## **APPENDIX D**

*Consultation Correspondence with Randwick City Council*

**RE: Draft Environmental Assessment Report for the proposed installation of in-ground stormwater treatment unit at P&O Shipping Terminal at 42 Friendship Road, Port Botany**

### *Draft Construction Environmental Management Plan*

Project		PORT BOTANY TERMINAL STORMWATER TREATMENT SYSTEM
Drawing Title		SEDIMENT AND EROSION CONTROL PLAN
Status	Preliminary	
Project No.	034	
Drawing No.	L1-06	
Rev.	A

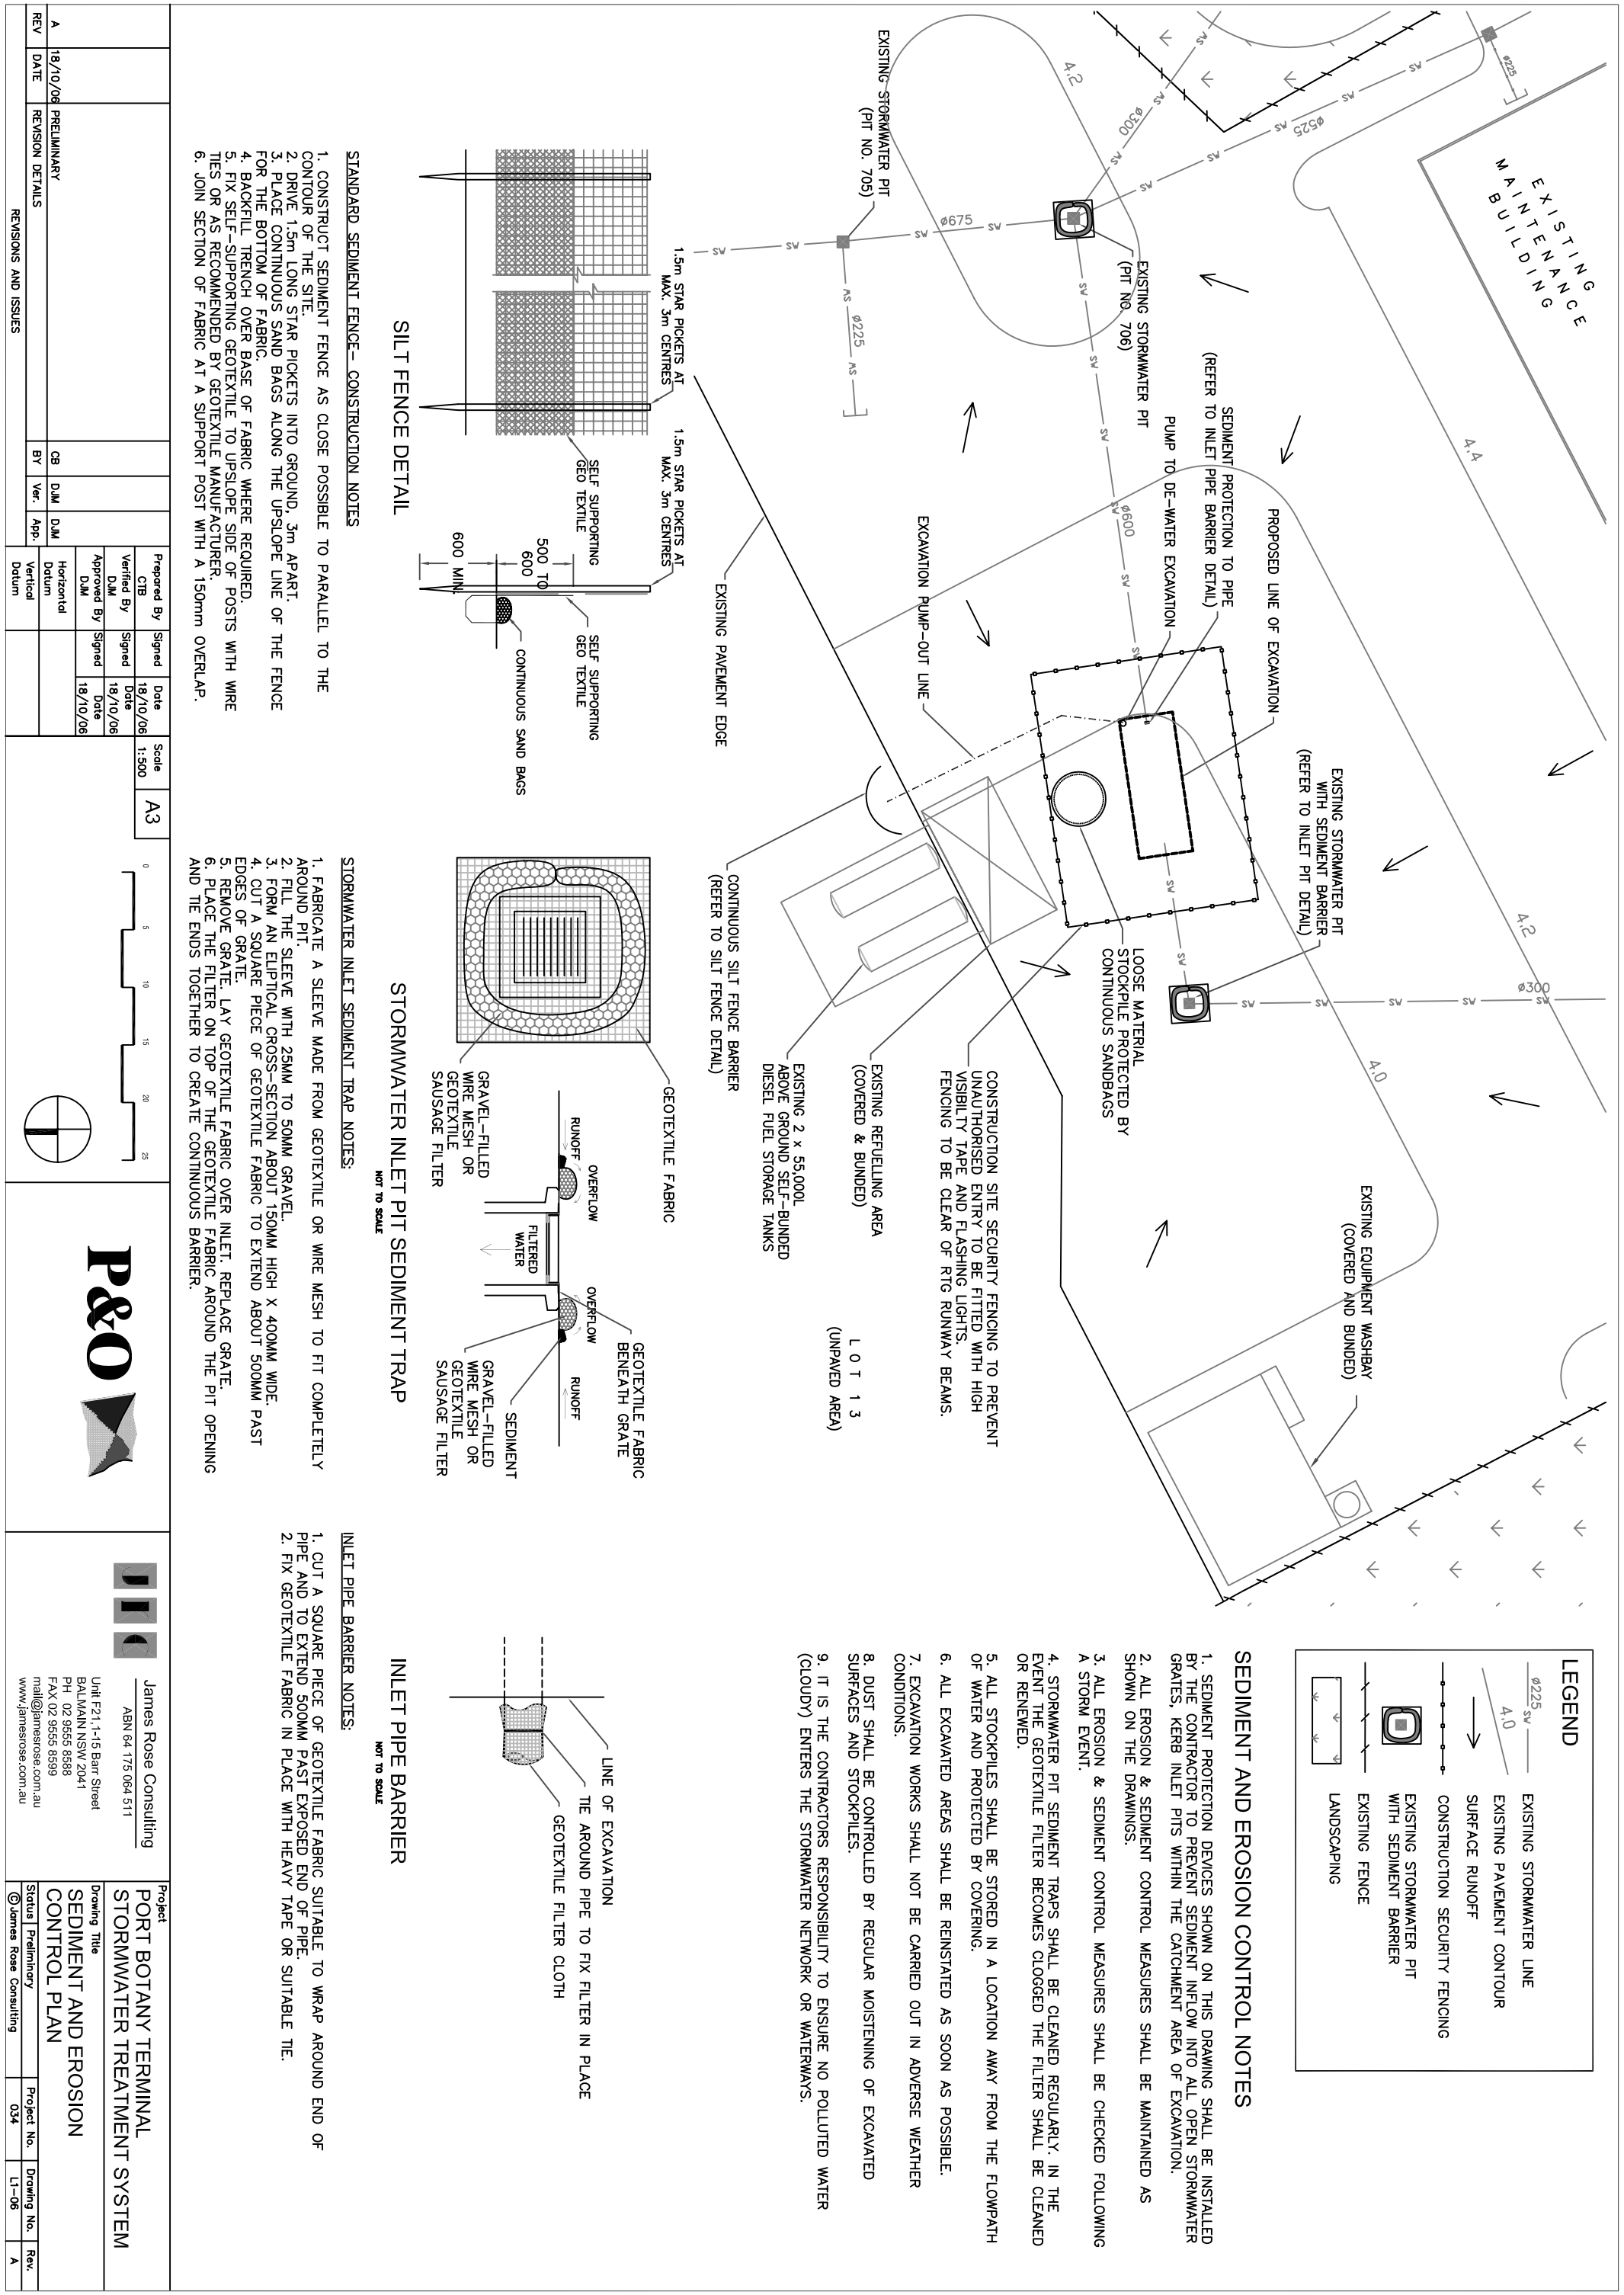
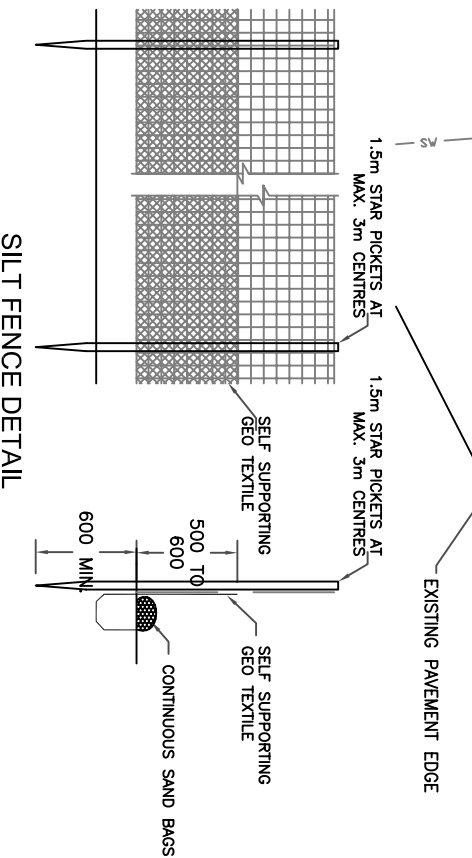
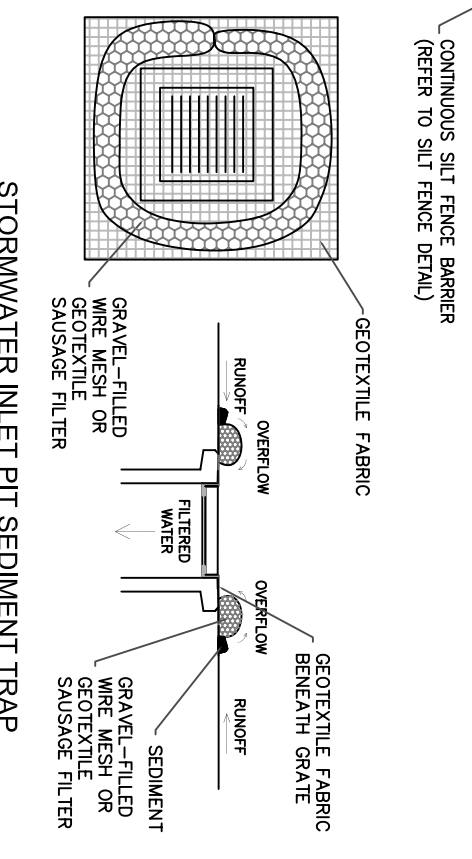
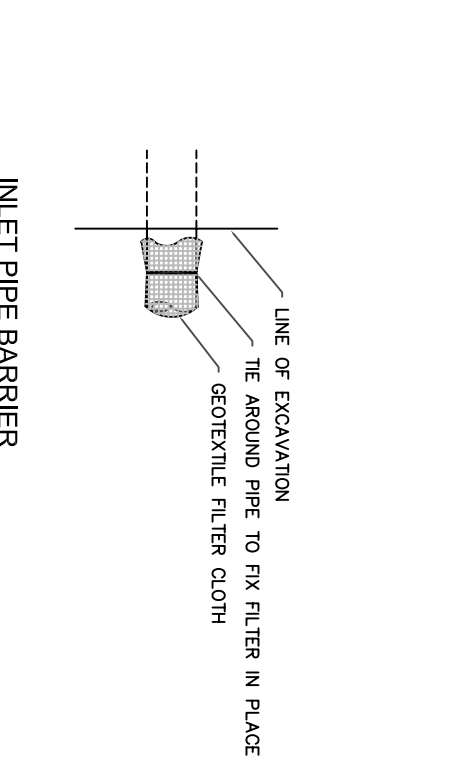
The mitigation measures for sediment and erosion control during construction works (Section 7.5 Page 18) has not been included in the draft Construction Environmental Management Plan (CEMP) Appendix E and should be included.
